September 19th 2017 City Council Meeting
Item # 6.1 BART Phase II Priorities and Preferred Alternatives

Roland Lebrun
ccss@msn.com
April 23 2017

Roland Lebrun
ccss@msn.com
BART Silicon Valley Phase II
Nov 19th 2014 meeting
Topics of conversation

Stacked Configuration at
Stations

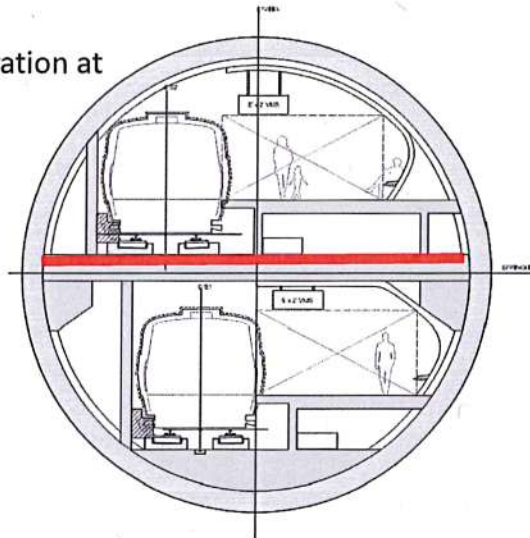
Please note that Platform Screen Doors (PSDs) are designed to stop smoke from entering the station platforms but are missing from the above diagram.

Point of Safety

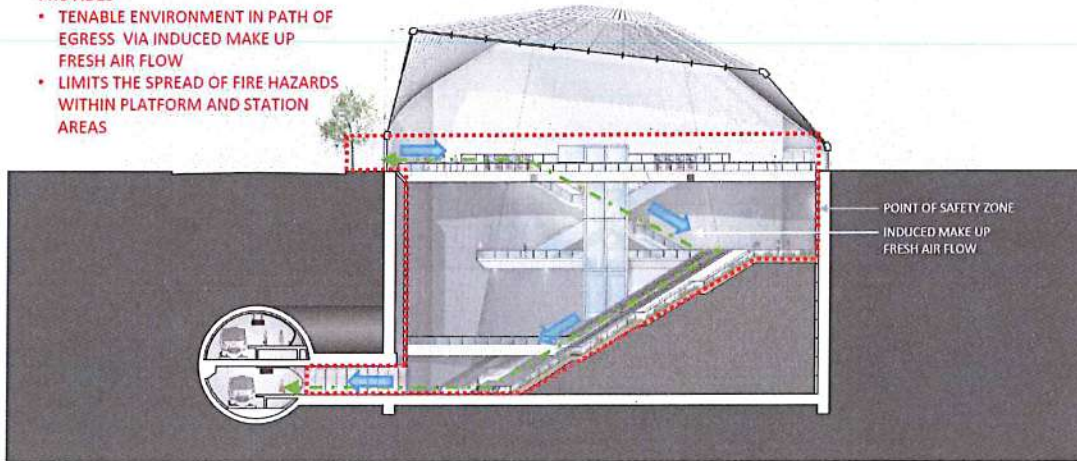
Once again, Crossrail station design is superior in an emergency because the incident platform (the platform connected to the incident tunnel) is connected via multiple cross-passages to the non-incident platform and/or the central circulation tunnel. Each platform and the central circulation tunnel are in turn connected to the station ticket halls located at the opposite ends of the platforms.

This design eliminates the need for passengers to walk up to 300 feet along a smoke-filled platform to reach an emergency exit

Figure B-42

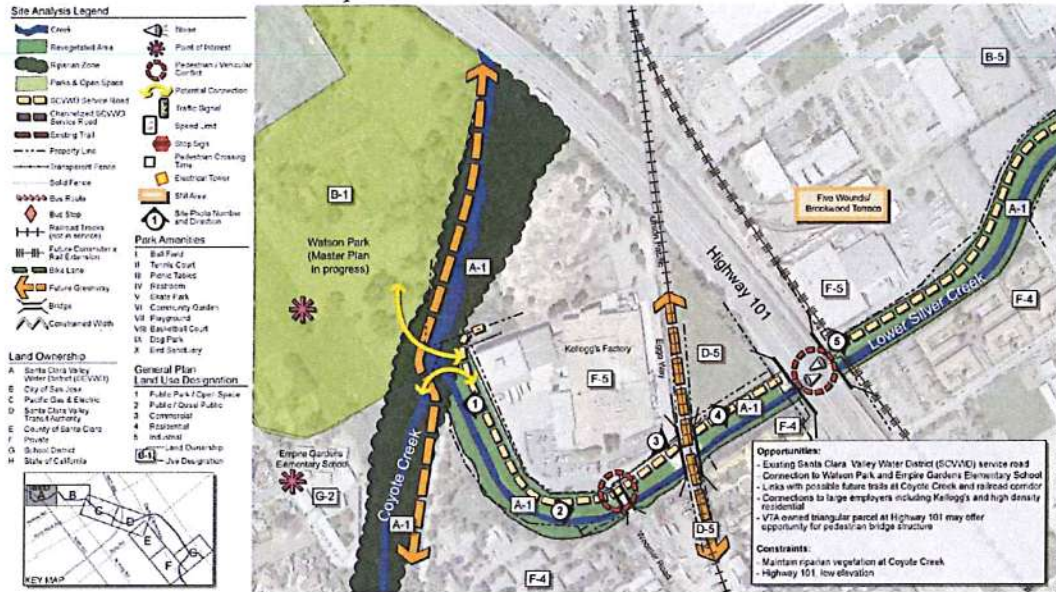
I would like to confirm that the only known station alignment that does not conflict with the December 2007 environmental clearance for the Lower Silver Creek Trail (<http://www.sanjoseca.gov/DocumentCenter/View/9361>) is the diagonal between 28th Street and 101 with a tunnel portal east of 101

Figure B-47

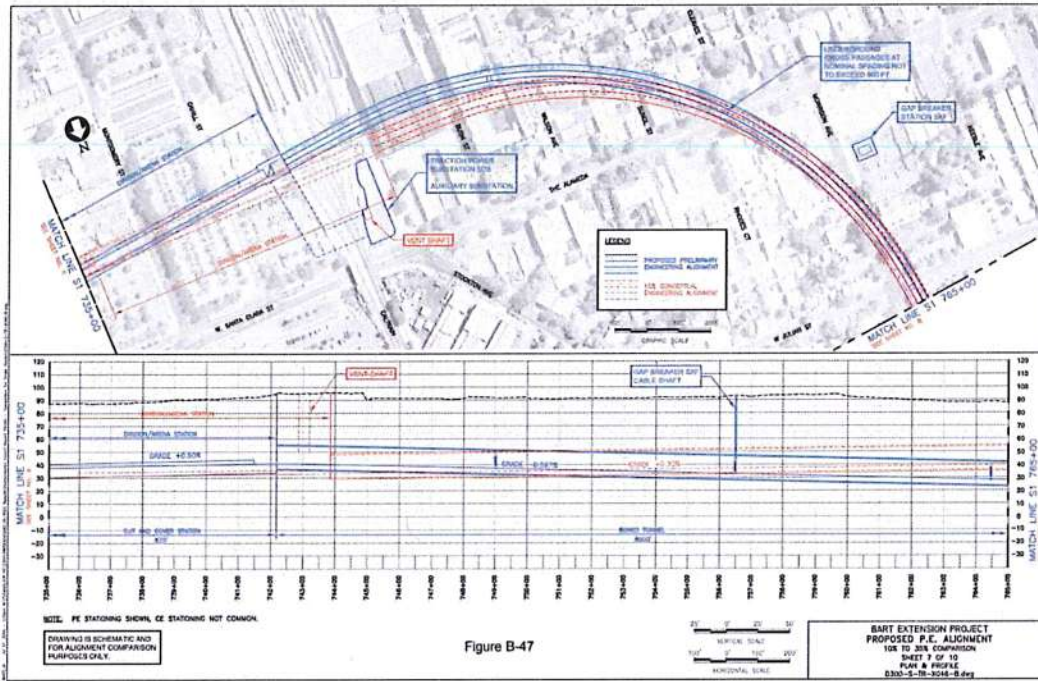
- Restoring the original BART station box alignment parallel to Santa Clara Street
- Relocating the parking structure to the other side of Santa Clara to act as a buffer for the transit center pedestrian core
